Representation on behalf of the residents of 20 Cecil Road in objection to AWDM/0388/26 Planning application for a two storey side extension, single storey rear extension and rear dormer at 22 Cecil Road, Lancing, BN15 8HN.

I write in my capacity as Director of **LF Architecture Ltd** on behalf of my clients, the residents of **20 Cecil Road**, who are the adjoining occupiers directly affected by the proposed development at **22 Cecil Road**.

Extract from drawing 05 – First Floor AS Proposed showing 2no. first floor bathroom windows in the North Elevation

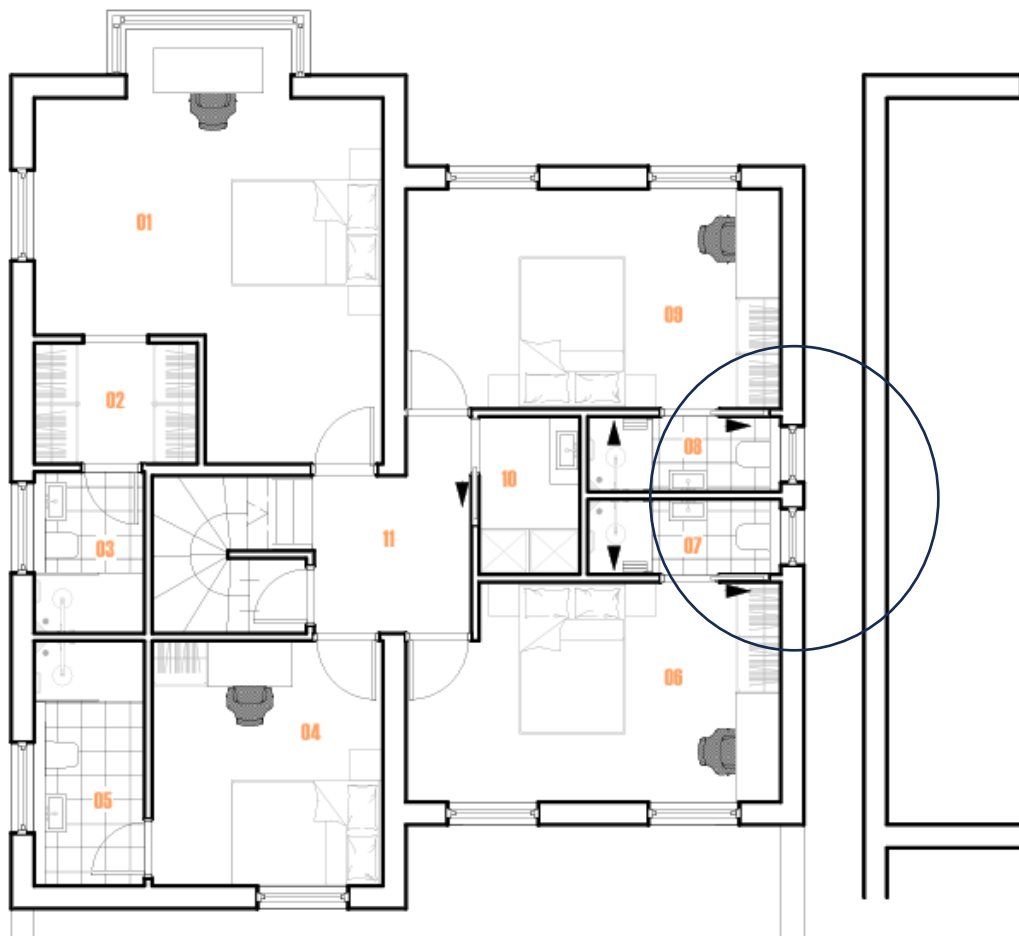
There is also an inconsistency between the submitted drawings. Drawing 05 appears to show proposed first-floor bathroom windows on the north elevation facing towards No. 20. However, those windows appear to be omitted from the proposed north elevation on Drawing 11. This is a material inconsistency because the north elevation directly affects my clients' property and is relevant to privacy, overlooking and the proper assessment of the side elevation.

The Council should not determine the application on inconsistent drawings. The applicant should be required to submit corrected drawings showing the proposed north elevation accurately, including all proposed first-floor windows and any changes to eaves, wall or roof height.

The inconsistency between Drawing 05 and Drawing 11 makes this issue more significant. If the windows are proposed, they must be shown accurately on the north elevation and controlled by condition. If they are not proposed, the first-floor plan should be corrected.

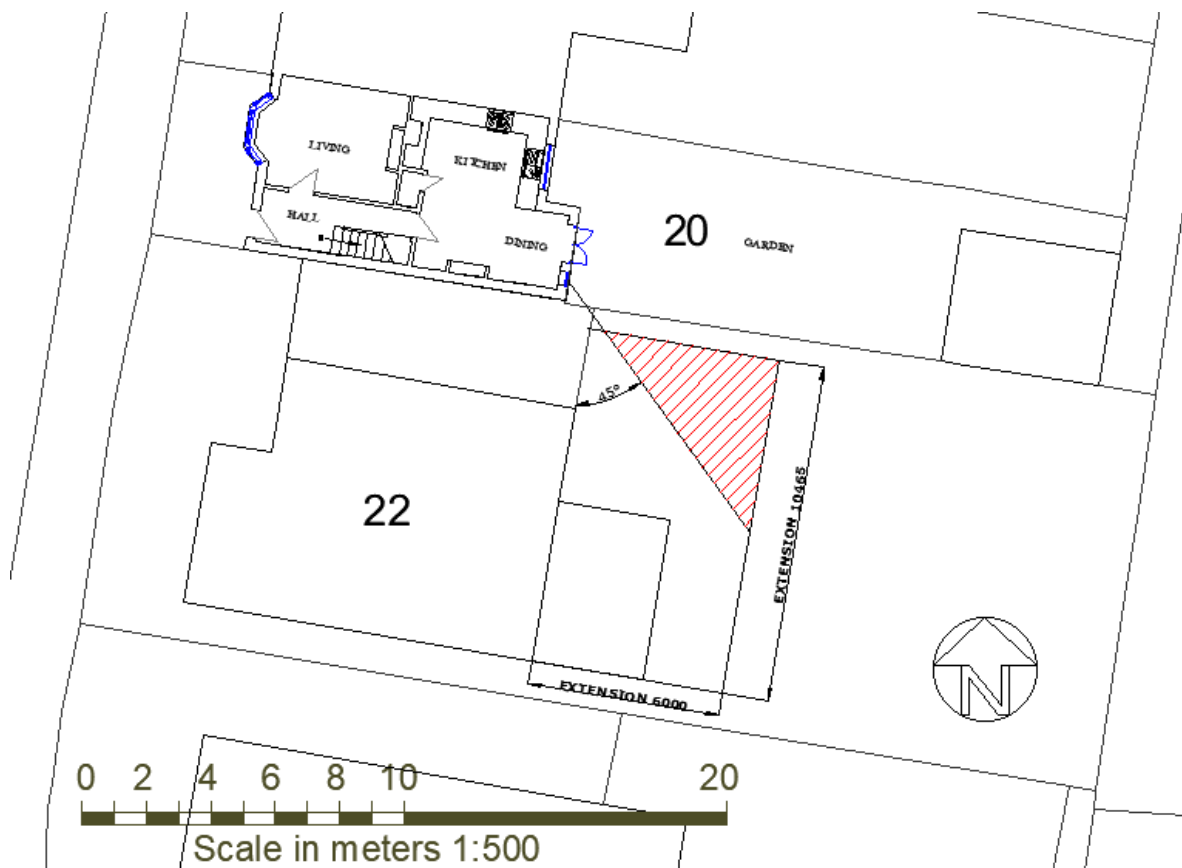
Having reviewed the submitted drawings and the relationship between the properties, the proposed single-storey rear extension appears to project beyond the 45-degree daylight / outlook line when assessed from the dining room window at No. 20. The extent of the projection is material. It is not a minor technical issue. It indicates likely harm to the amenity of No. 20 through loss of daylight, reduced outlook and increased enclosure.

The area of the proposed extension shown hatched in red on the OS plan below indicates the extent of the proposal that would project beyond the 45-degree daylight / outlook line when assessed from the dining room window at No. 20 Cecil Road. This supports my clients' objection that the proposal would cause unacceptable harm to their residential amenity through loss of daylight, reduced outlook and increased enclosure.

In the alternative, the proposal should be amended so that the single-storey rear extension does not project beyond the 45-degree daylight / outlook line from the dining room window at No. 20 and adequate parking provision is retained or properly justified.
